**FINAL DRAINAGE REPORT
FOR
SCHMIDT PARCEL EARLY GRADING**

**July 2022
Project No. 25188.13**

**PCD Filing No.:
CDR-22-007**

PROPOSED DRAINAGE MAP
SCHMIDT PARCEL
JOB NO. 25188.13
07/20/2022
SHEET 1 OF 1

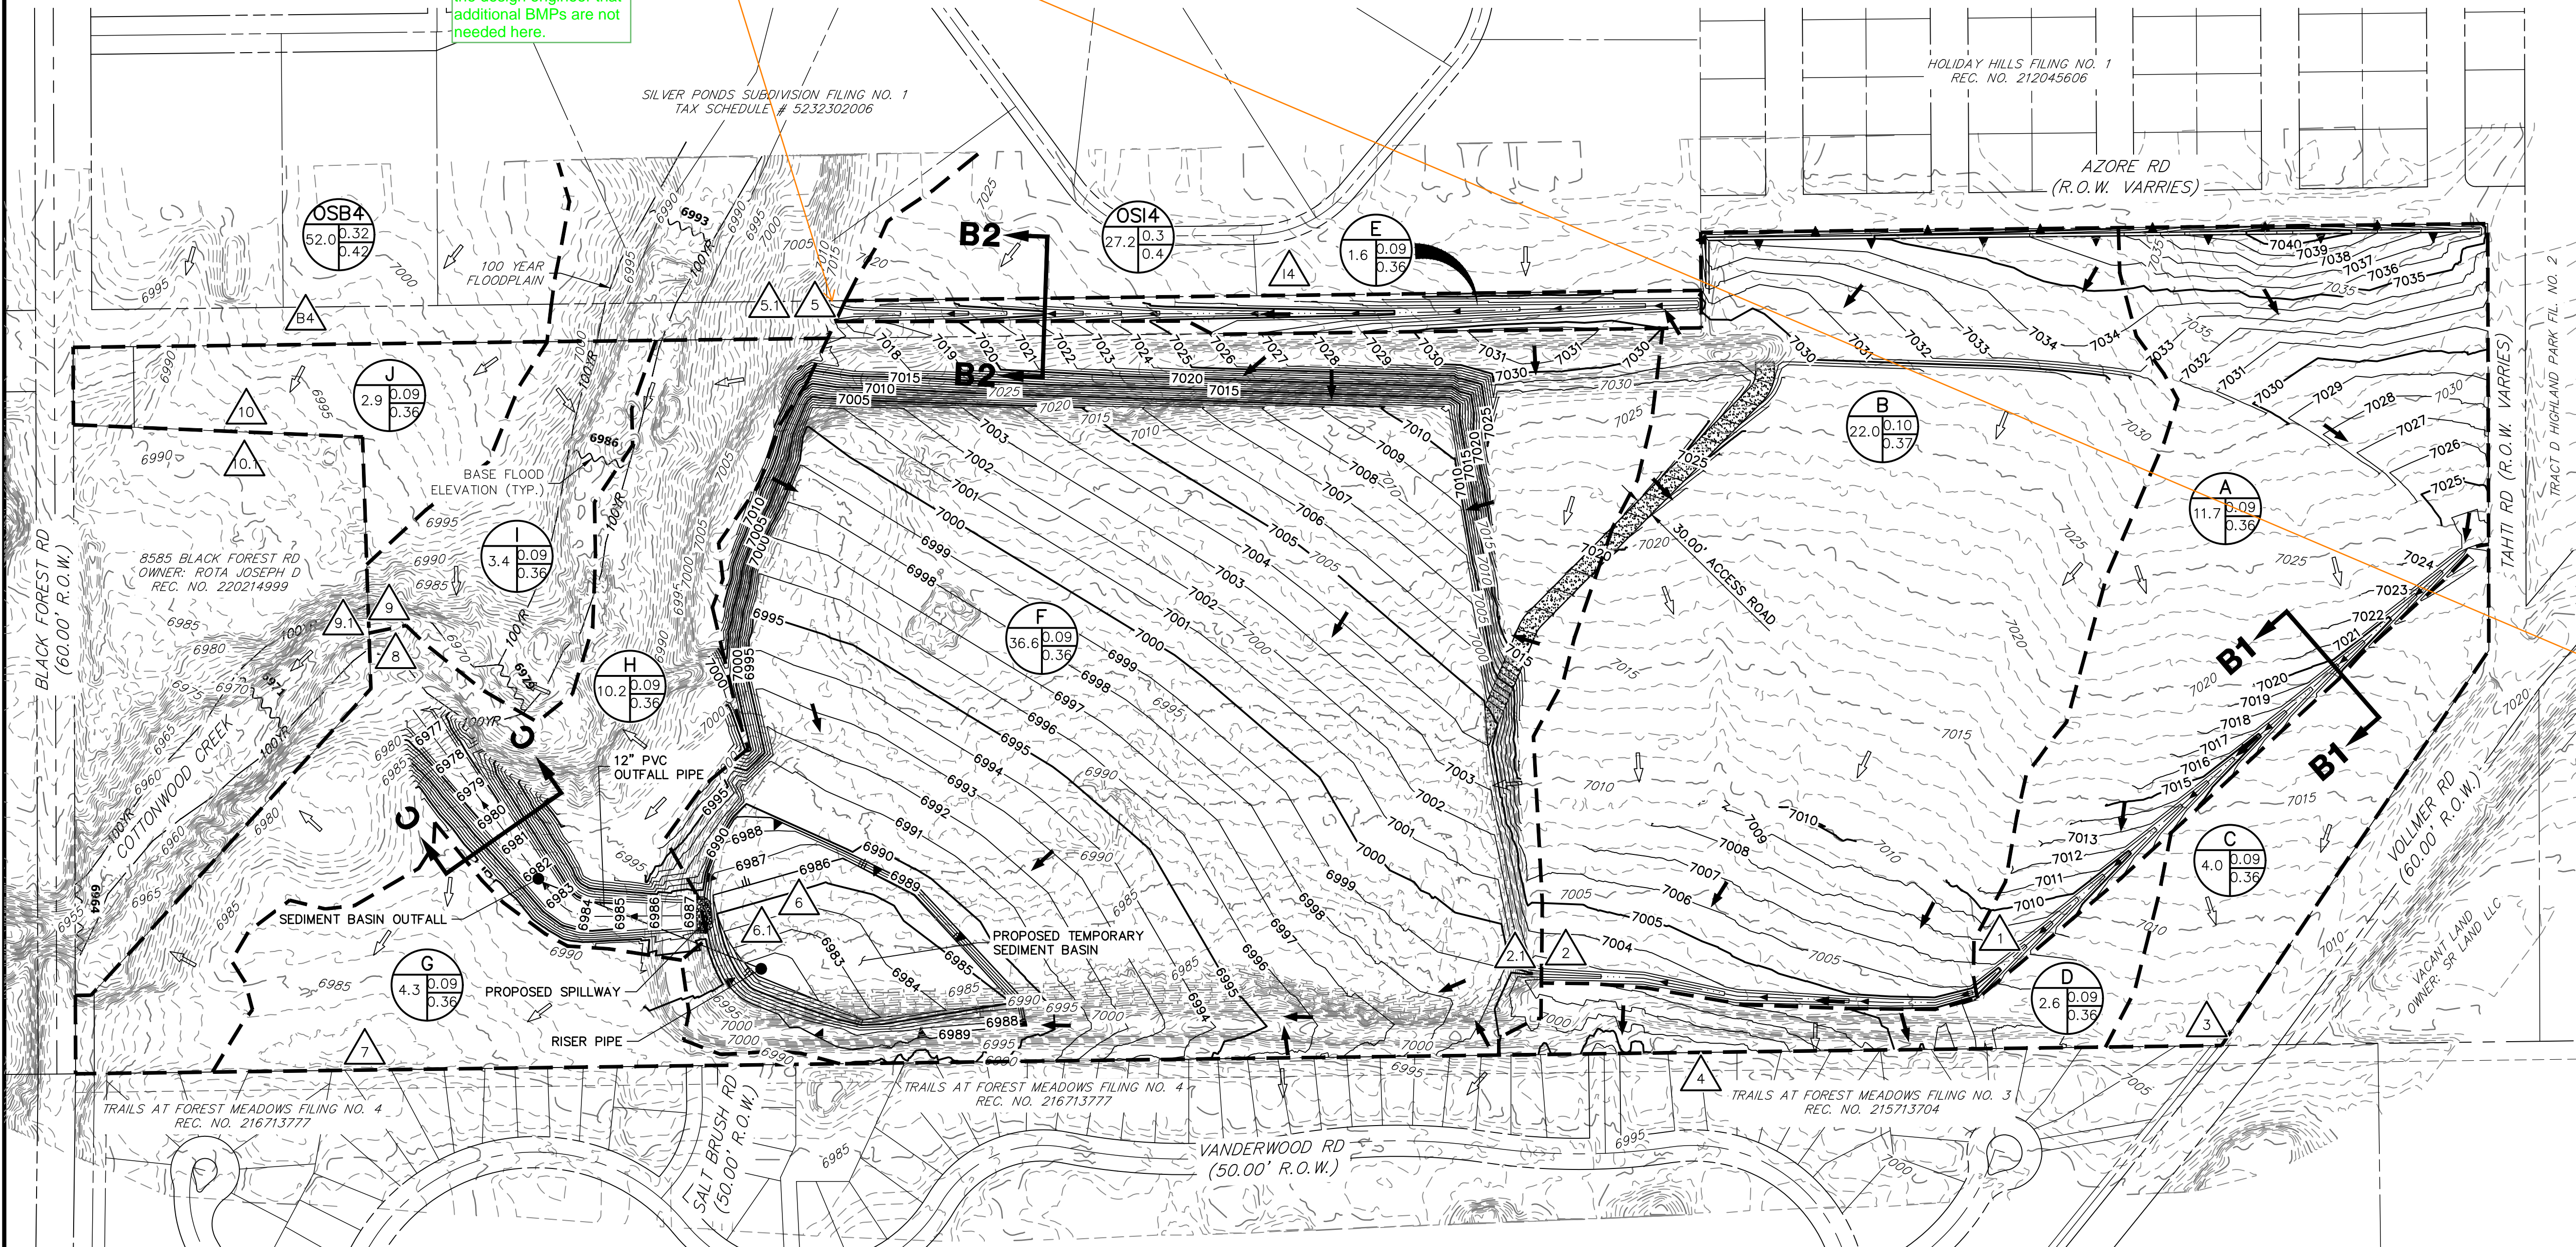
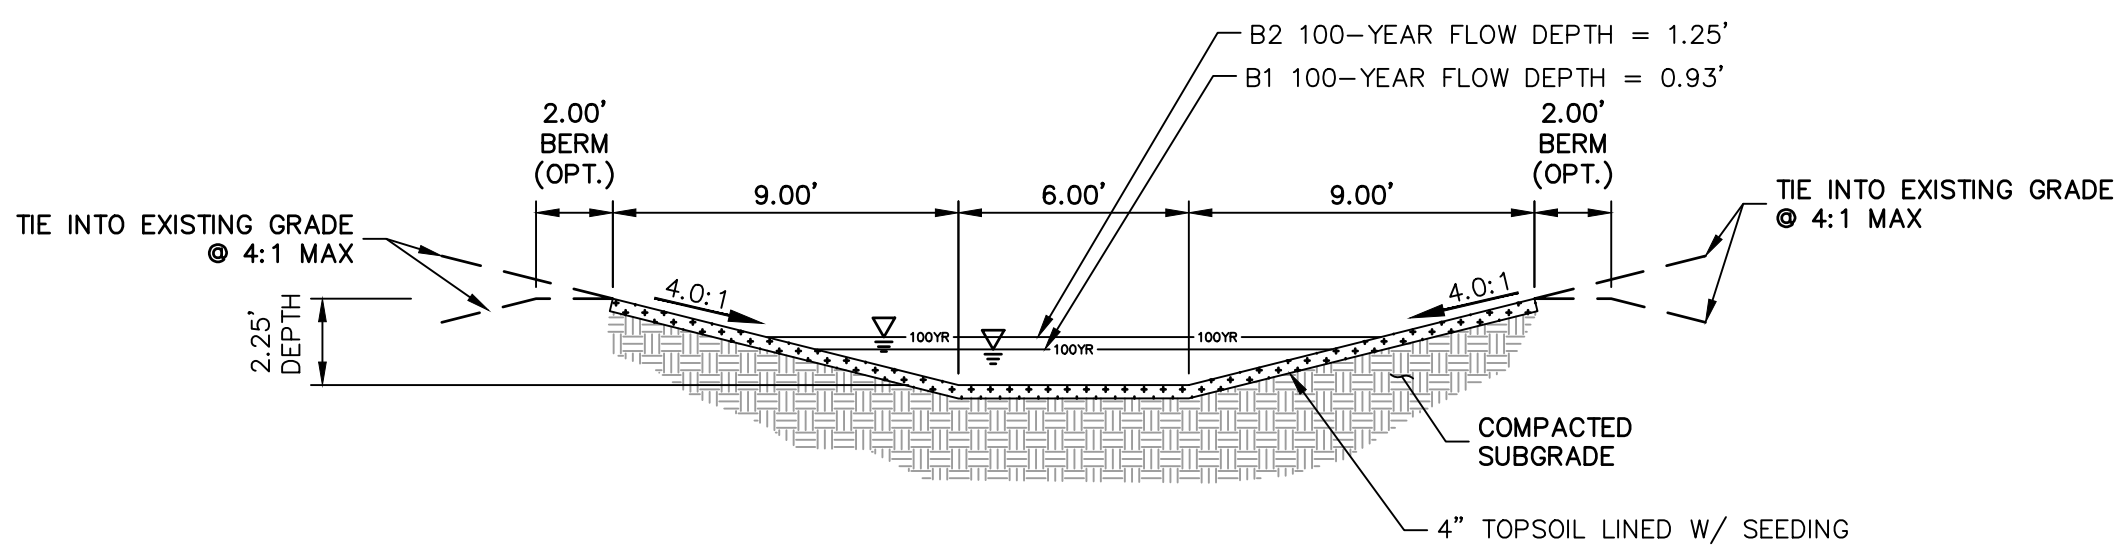
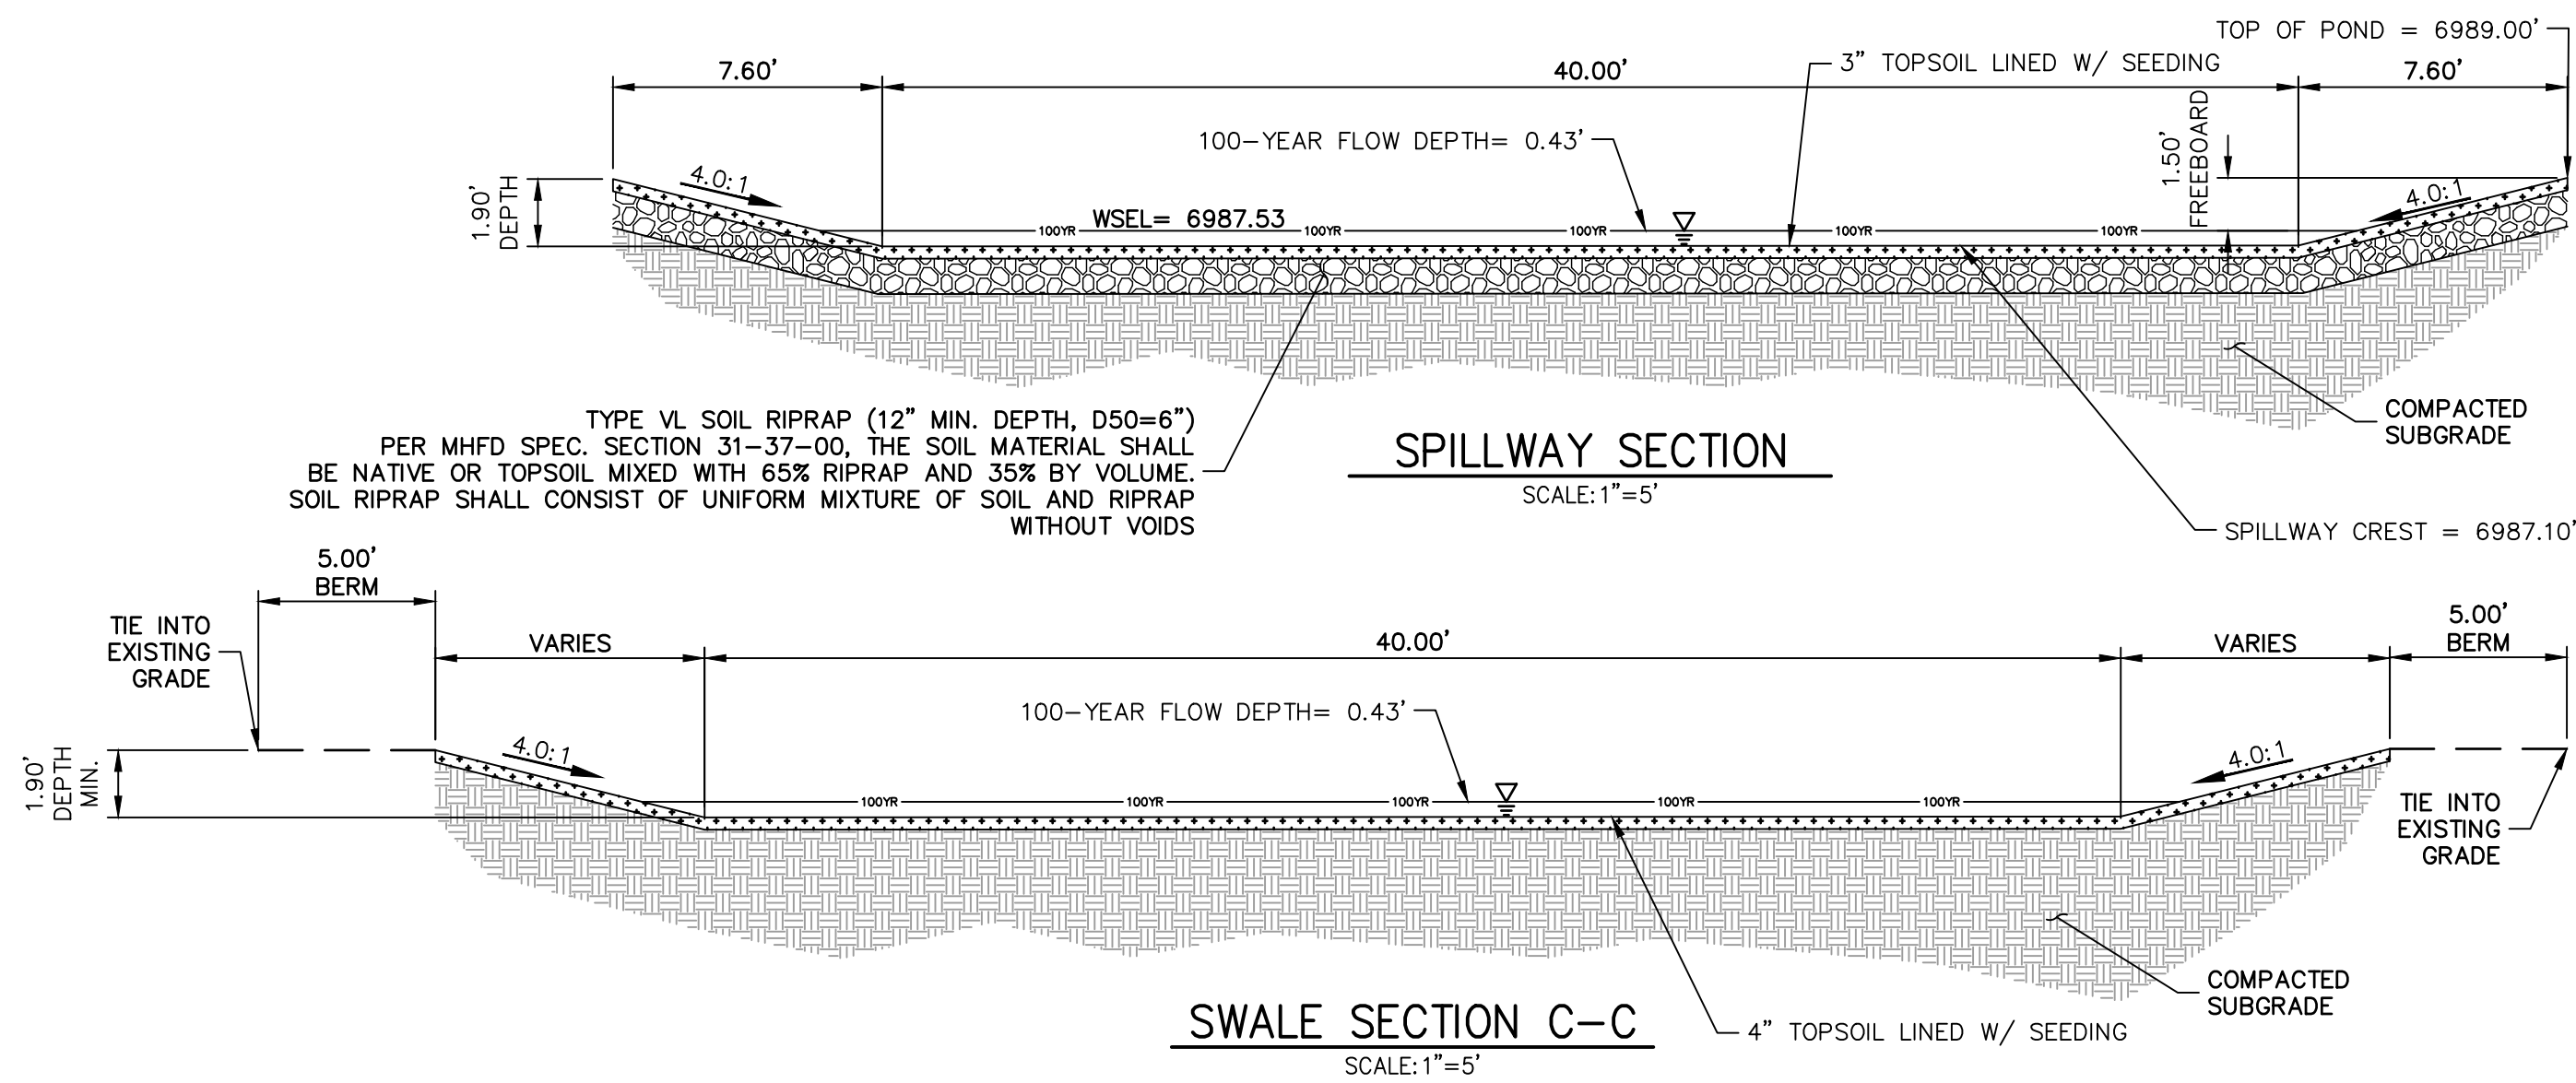
Velocity in swale B2 is less than 5 ft/s and is therefore in stable condition. The flows have decreased in this area compared to the existing condition. The outfall is stable in existing conditions and there is no evidence of erosion at the outfall. It is the opinion of the design engineer that additional BMPs are not needed here.

Given the flowrates exiting this swale, consider need for additional armoring/BMPs from the swale to the creek.

Add "PCD File No. CDR-22-007" to both drainage maps.
